Brocade Fabric OS v5.0.5c

Release Notes v1.0

January 19, 2007

Figure 12-1 FICON CUP Management, Port Based Routing.

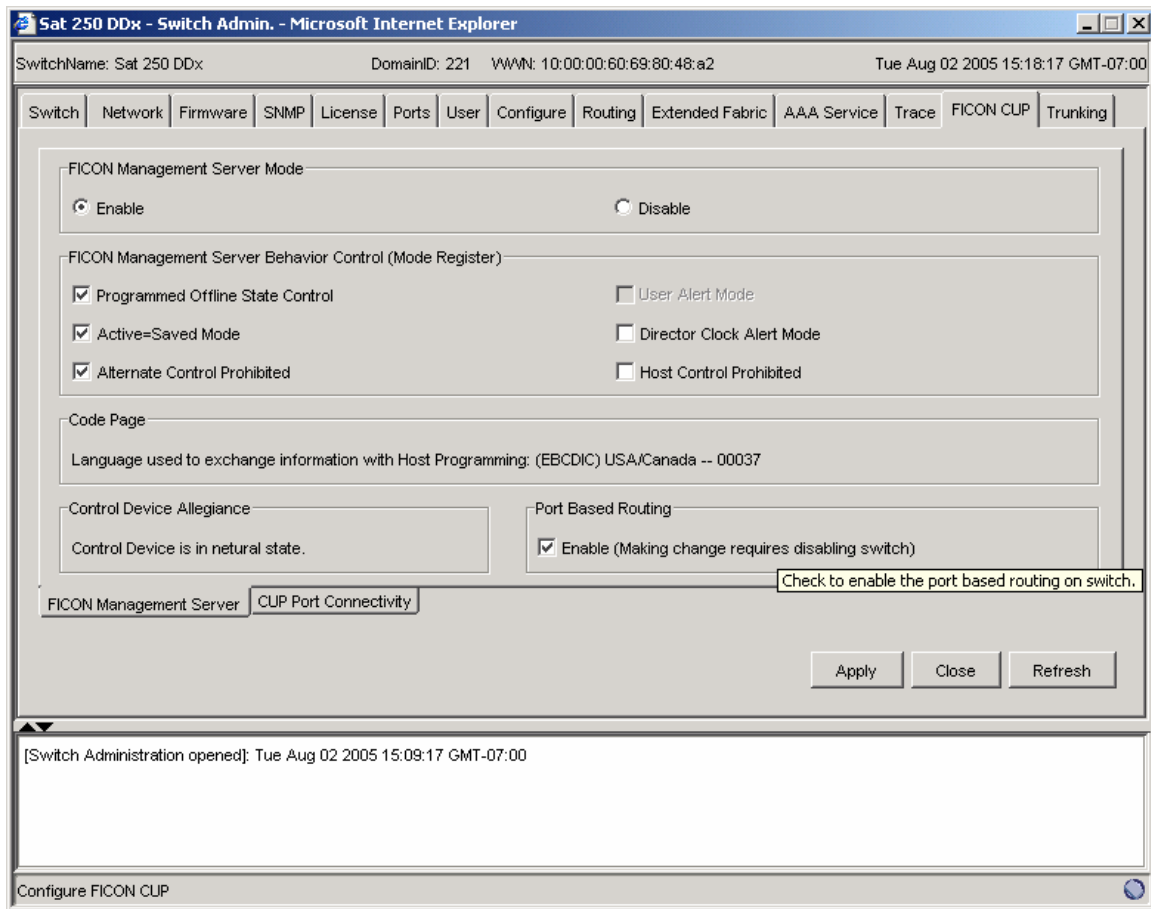
In Chapter 12, “Administering FICON CUP Fabrics,” on page 12-1, add a new section “Enabling Port Based Routing”

4. Click the **Enable** radio button to enable the port-based routing policy.

Figure 14-1 Accessing Performance Graphs

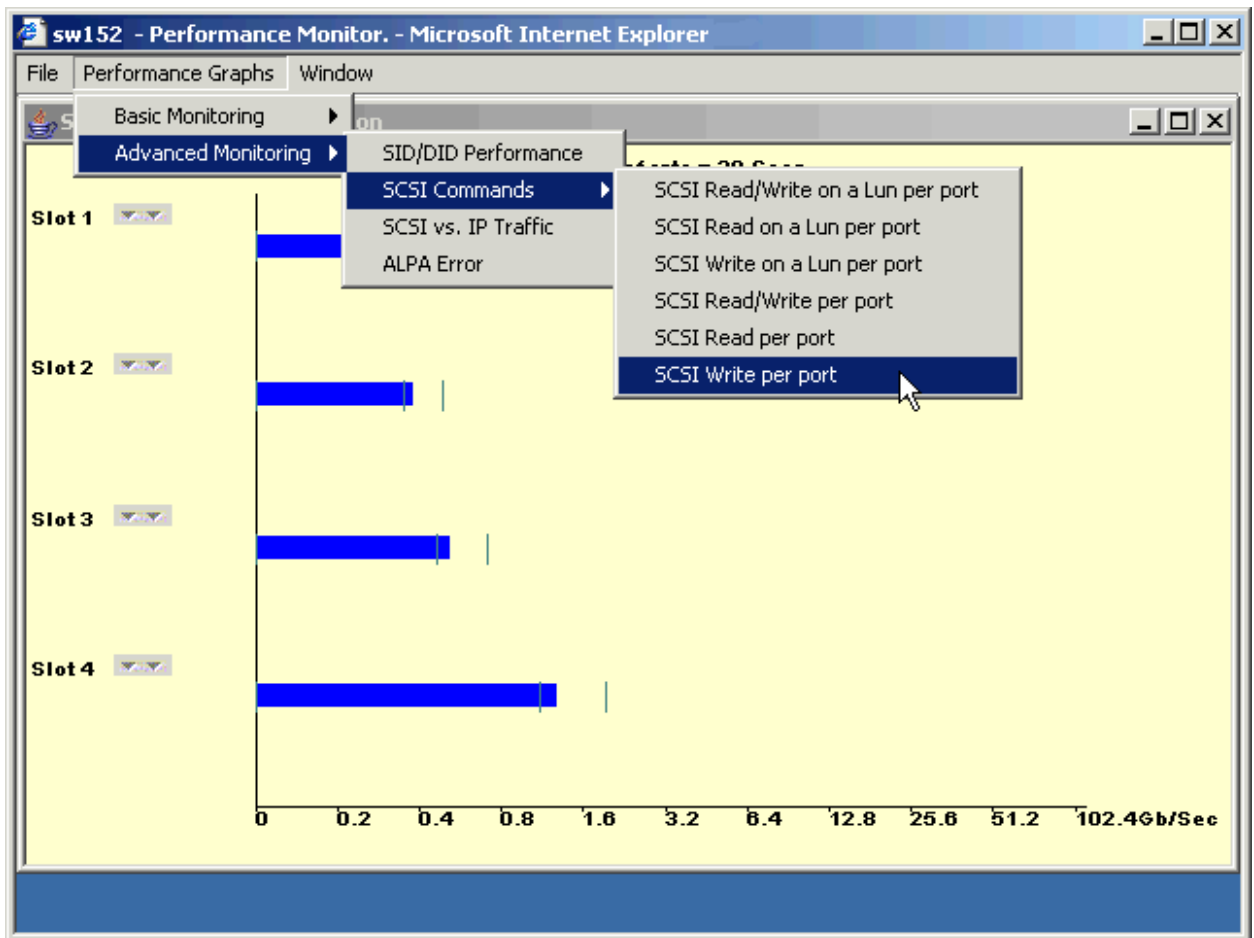
On page 14-3, replace Figure 14-1 with this one:
